RIGHT OF WAY PLAN OF THE
BENSON - MAMMOTH
STATE HIGHWAY
PROJECT NO. S-358-706
PIMA
COUNTY

BENSON-MAMMOTH HIGHWAY
REDINGTON BRIDGE-PINAL COUNTY LINE SEC.
PIMA COUNTY

PROJECT NO.	S-358-706
DRAWING NO.	D-10-T-321
SHEET NO.	2 of 17
DRAWN BY	J.G.
DATE COMP.	8-4-70
SCALE	
CONSULTANT	ENG. CORP OF AMERICA

PROJECT NO.	S-358-706
DRAWING NO.	D-10-T-321
SHEET NO.	11 of 17
DRAWN BY	P.U.H.
DATE COMP.	8-4-70
SCALE	1"=100'
CONSULTANT	ENG. CORP. OF AMERICA

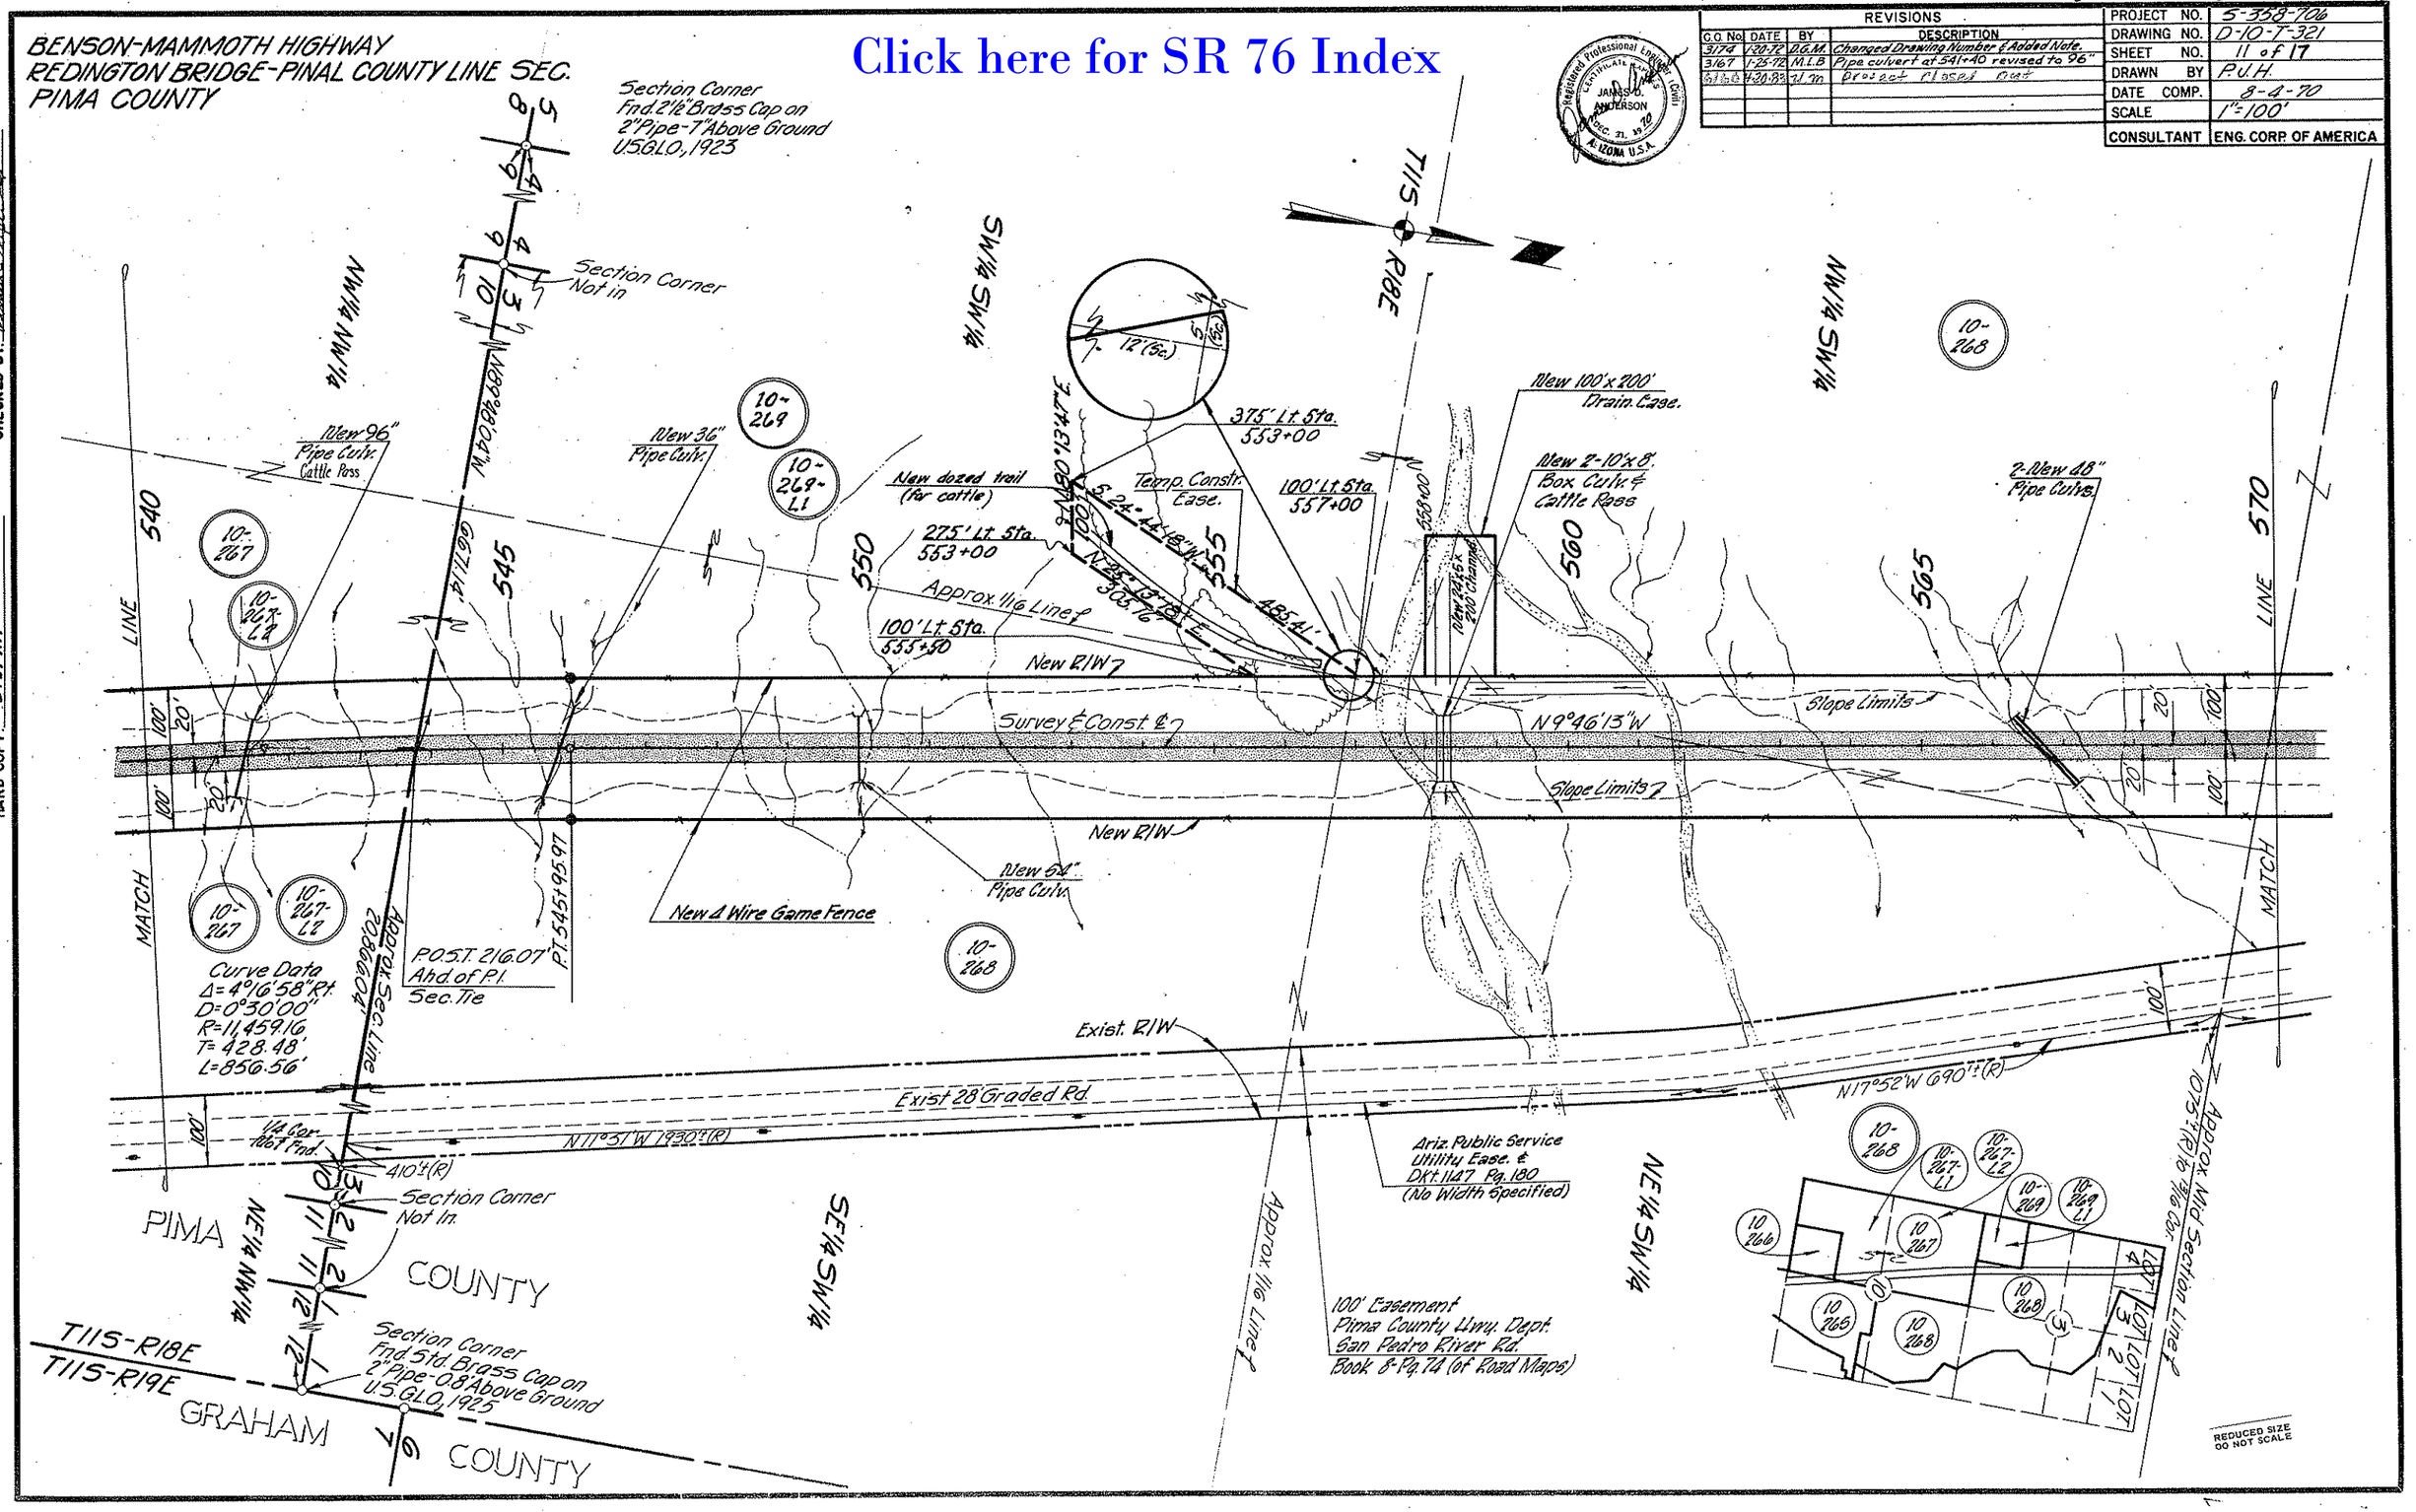
REVISIONS			
C.O. No.	DATE	BY	DESCRIPTION
3174	1-20-72	D.G.M.	Changed Drawing Number & Added Note.
3167	1-25-72	M.L.B.	Pipe culvert at 541+40 revised to 96"
3160	4-20-83	[illegible]	Project closed out

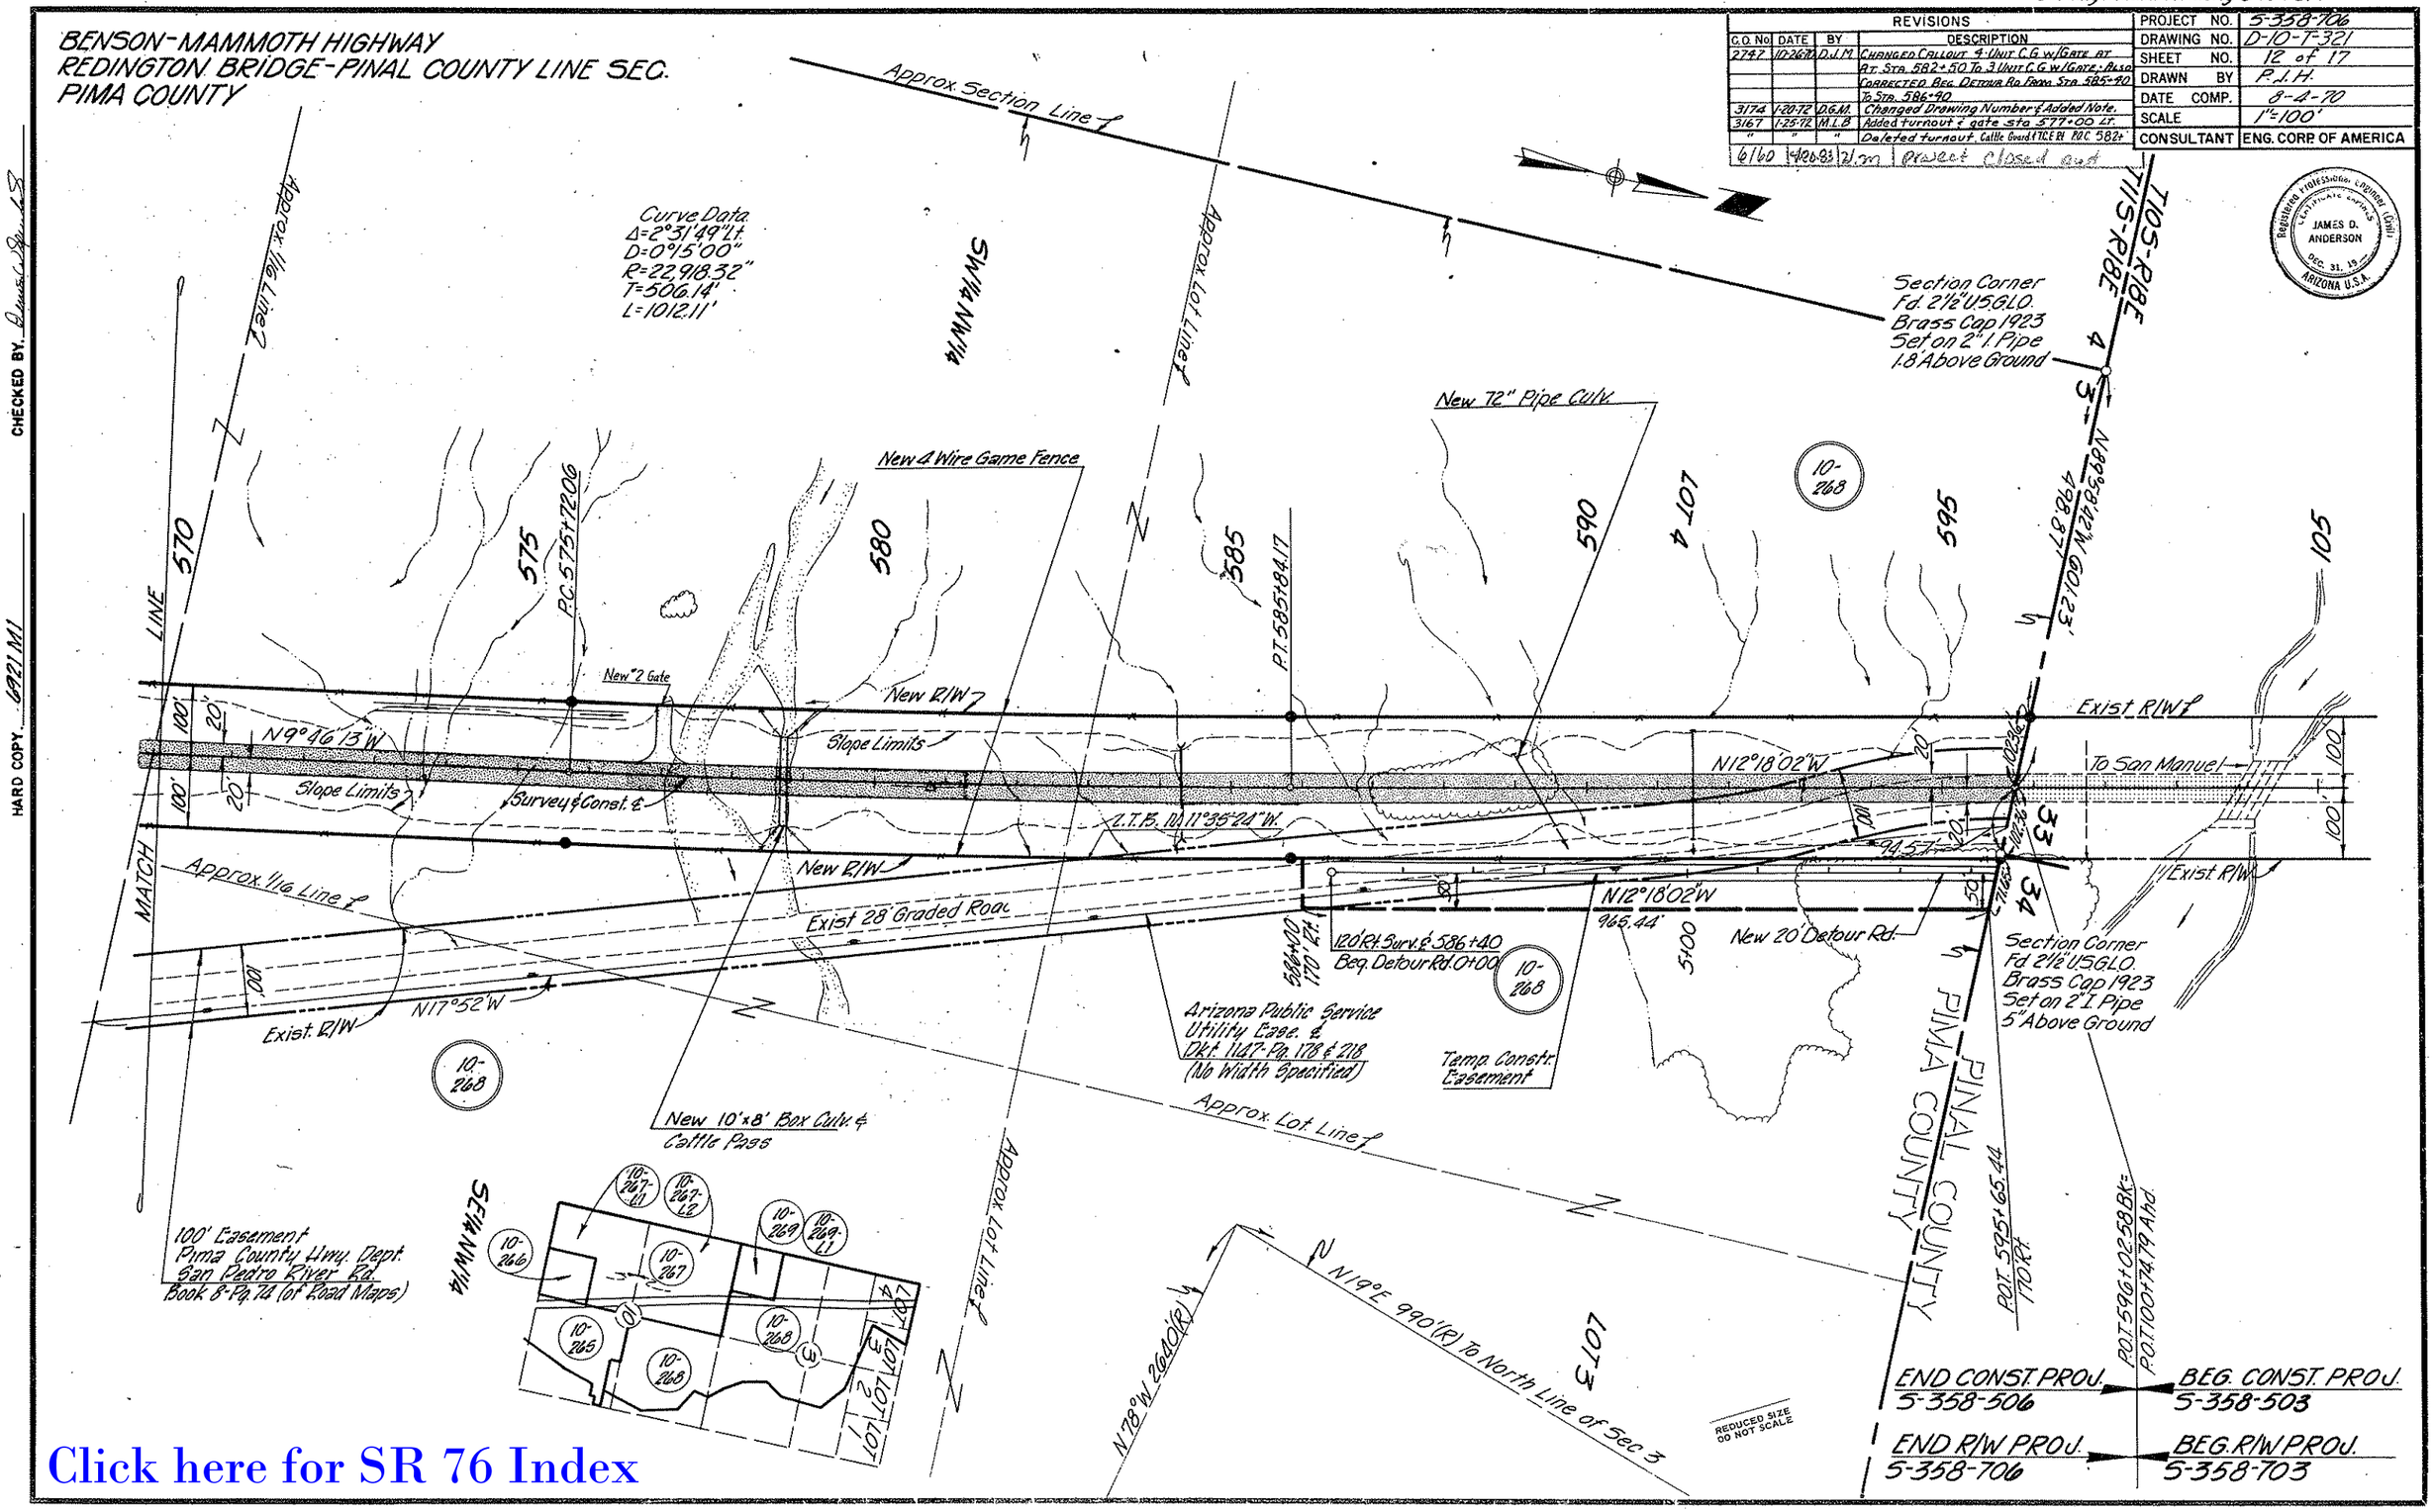
REVISIONS					
C.O. No.	DATE	BY	DESCRIPTION	PROJECT NO.	5-358-706
2747	10-26-71	D.J.M.	Changed Callout 4-Unit C.G. w/Gate at Pt. Sta. 582+50 To 3 Unit C.G. w/Gate; Also Corrected Beg. Detour Rd From Sta. 585+80 To Sta. 586+40	DRAWING NO.	D-10-T-321
3174	1-20-72	D.G.M.	Changed Drawing Number & Added Note.	SHEET NO.	12 of 17
3167	1-25-72	M.L.B.	Added turnout & gate sta. 577+00 Lt.	DRAWN BY	P.J.H.
"	"	"	Deleted turnout, Cattle Guard & TCE at P.O.C. 582+	DATE COMP.	8-4-70
6160	4-26-83	J.L.M.	Project closed out	SCALE	1"=100'
				CONSULTANT	ENG. CORP. OF AMERICA
